BEECH

47-6-8 Beech (Was Service Note 1 of AD-757-2 and Service Note 1 of AD-2-582-2.)

FIGURE 1

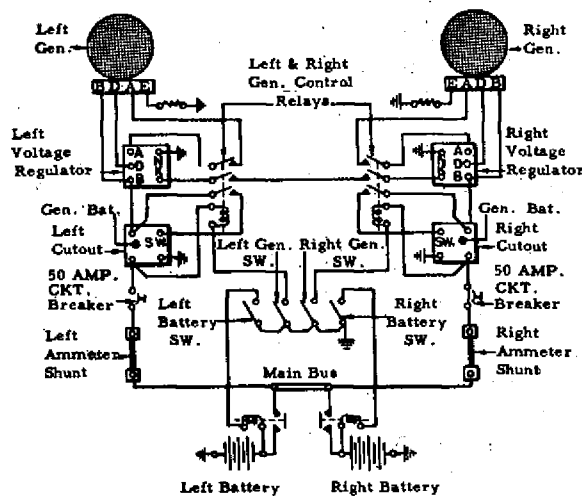
In accordance with Figure 1 install a three-pole-single-throw relay, General Electric No. CR2791-B100G3 or equivalent, for the control of each generator. The operating coil of the left generator relay should be controlled by a single-pole-single-throw "ON-OFF" switch mounted on the pilot's control panel adjacent to the left battery switch, and should be labeled "LEFT GEN. SW.". The operating coil of the right generator relay should be controlled by a single-pole-single-throw "ON-OFF" switch mounted on the pilot's control panel adjacent to the right battery switch and should be labeled "RIGHT GEN. SW.". The battery and generator switches should be located adjacent to each other in the order shown on Figure 1,

and should be provided with a suitable gang-bar such that pilot can throw the four switches to the "OFF" position in a single operation.

The generator control relays may be mounted in any convenient junction box or in a separate box provided therefor. Choice of relay location should be such that the length of generator field leads are kept to a minimum.

In accordance with Figure 1 install a 50-ampere trip-free circuit breaker, Spencer Thermostat Co. PLM-50 or equivalent, between the battery terminal of each generator cutout and its respective ammeter shunt. The circuit breakers should be accessible in flight and labeled respectively: "LEFT GEN. CIRCUIT" and "RIGHT GEN. CIRCUIT."

FIGURE 2

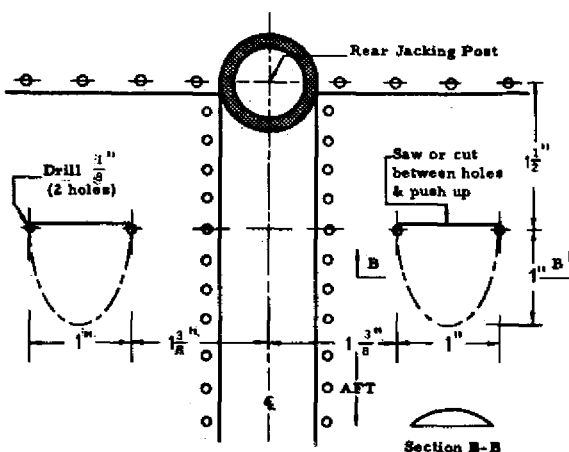
In order to provide better tail cone drainage, add two drain holes in the tail cone and two 1/4-inch drain holes in the fuselage bulkhead No. 15 as shown in Figure 2.

FIGURE 1

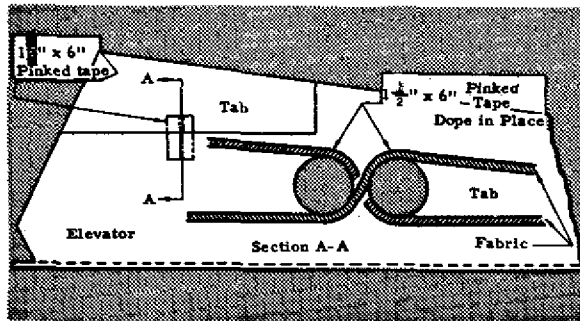
As a result of a recent failure of the elevator trim tab in flight, the modification of the trim tab attachment to the elevator as shown

in Figure 1 should be made.
